19.7-01

TECHNICAL BULLETIN

Powertrain 4L80-E Transmission – Noisy Rear Mount – Modification Procedure

MODEL 1995 MY
XJR & XJ12
VIN XJR 720001-734671
XJ12 720001-738561

ILLUSTRATION 1

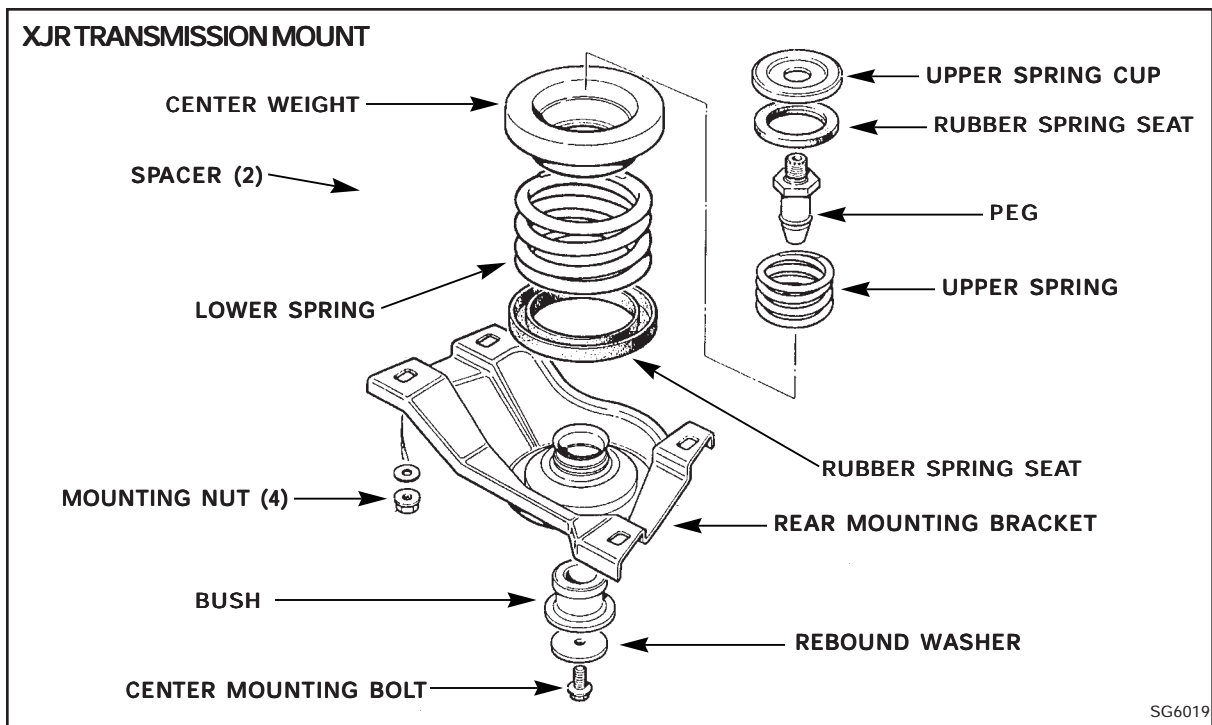
Some vehicles equipped with Powertrain 4L80-E transmissions within the above VIN ranges, may exhibit a knock or squeak from the area of the transmission tunnel. The noise may be traced to movement of the damper peg of the rear transmission mounting against the surrounding foam bush.

An improved peg and bush was introduced in production from VIN 734672 for the XJR and 738562 for the XJ12.

5. Align tool set MS53 on the fender channels and with the rear lifting bracket. Tighten the nut of the support hook to support the engine.
6. Raise the vehicle and remove the center mounting bolt (illustration 1) and the rebound washer from the transmission mount.

13. Install the replacement peg with the upper spring cup on the transmission. Torque the peg to 67.5 - 81.5 lb ft (90 - 110 Nm).
14. Install new upper and lower rubber spring seats to the upper and lower springs.

18. Raise the jack, compressing the two springs, until the bracket and spacers completely contact the vehicle body, ensuring that the peg is centered in the bush. Install the retaining nuts and washers.
